Access Compliance Report

Public Rights-of-Way

Intersection ID: 32115	Main Street: COLE_MILL_RD	Cross Street: GALT_Y_LN	Location: S
ADA ID: 170C0083D9A5	Ramp Type: BlendTrans1	Initial Pass/Fail: Pass	Overall Compliance: No
			Severity Score: 15.25

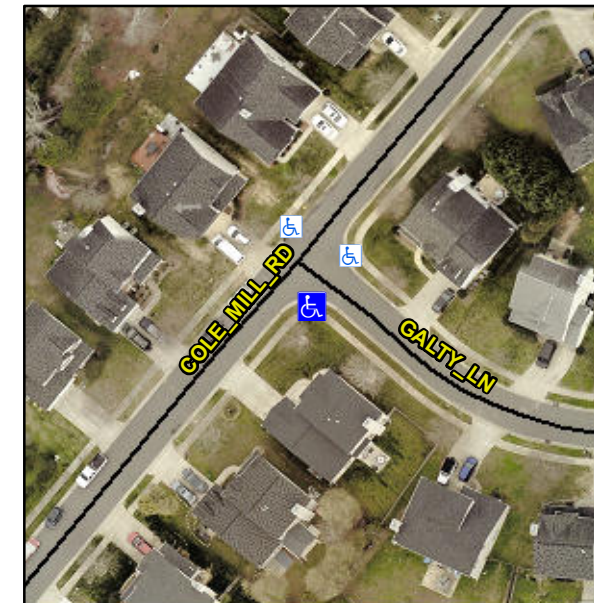
Not Found, R304.5.3, R304.2.1, R305, R304.5.4

Compliance	Description	Data	Compliance	Description	Data
N/A	Ramp Length (in)	48.0	Yes	BlendTrans Slope (%)	2.7
Yes	Ramp Width (in)	50.0	No	BlendTrans XSlope (%)	3.3
N/A	Flare Type LT	Sloped	N/A	Flare Type RT	Sloped
N/A	Flare Slope LT (%)	1.2	N/A	Flare Slope RT (%)	2.1
N/A	Flare Traversable LT?	No	N/A	Flare Traversable RT?	No
No	Landing Length (in)	46.5	No	DWS Provided?	No
Yes	Landing Width (in)	50.0	N/A	DWS Contrast?	No
Yes	Landing Slope (%)	1.6	N/A	DWS Length (in)	N/A
No	Landing X Slope (%)	3.1	N/A	DWS Full Width?	No
N/A	Landing Curb? (Y/N)	No	N/A	DWS Offset (in)	N/A
N/A	Shared Landing?	No			
Yes	Gutter Ponding?	No	No	Gutter Slope (%)	8.9
Yes	Gutter Lip Ht (in)	0.0	Yes	Gutter X Slope (%)	1.7
N/A	Painted X Walk1?	No	N/A	Painted X Walk2?	No
	X Walk 1 Direction	To NE		X Walk 2 Direction	To NW
	X Walk 1 Width (in)	N/A		X Walk 2 Width (in)	N/A
	X Walk 1 Slope (%)	4.2		X Walk 2 Slope (%)	8.1
	X Walk 1 X Slope (%)	3.1		X Walk 2 X Slope (%)	0.7

N/A	Ramp inside XWalk1?	N/A	N/A	Ramp inside XWalk2?	N/A
	Road Slope (%)	2.4		Clear Space?	Yes
	Road X Slope (%)	4.5	N/A	Clear Space to XWalk (in)	N/A
Yes	Any Obstructions?	No	Yes	Storm Grate/Utility Hazard?	No
	Obstruction Type			Storm Grate/Utility Type	
		N/A			N/A
			Yes	Surface Condition? (G/P)	Good
			No	Curb Slope (%)	11.7

Remove & Replace Curb Ramp With Two New Directional Ramps or Equivalent. Remove & Replace Gutter.
